Questions and Answers

PZI-2024-1238

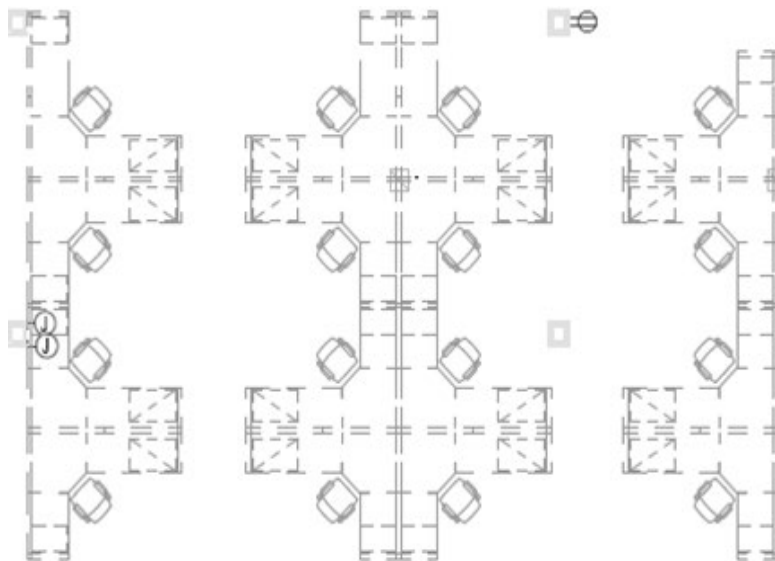
7. Is each half-shaded triangle/drop location to receive a 12-strand fiber optic cable? The below snippet would receive (15) 12-strand drops? (see picture below)

8. General note 1 states that drop locations are not shown and the contractor shall identify optimal pathways. Does each workstation receive (1) 12-strand OM2 fiber optic cable or is there a different quantity per workstation?

Answer: Correct - Each triangle is a 12 strand MM drop - 6 LC Connectors

Answer: Correct - Each desk will receive a 12 strand MM drop - 6 LC Connectors
